LiDAR Quality Assessment Report

OR Harney Co 2018

NGTOC
2019-08-28
S Ruhl

Checkpoint Distribution Image

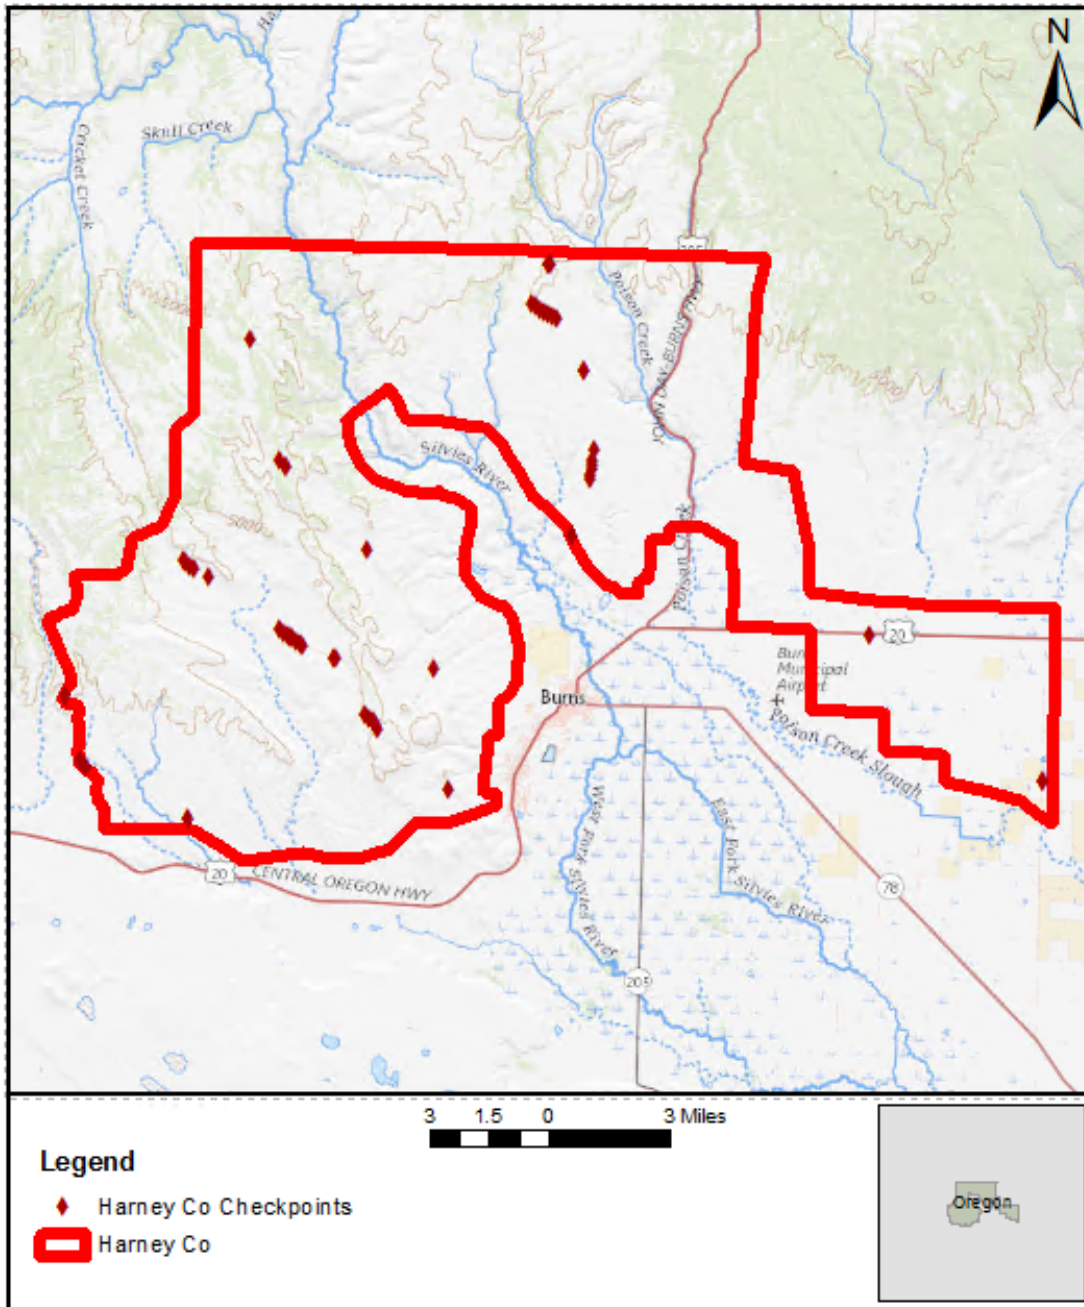
The checkpoints provided by the contractor are not distributed well and are clustered along roads.
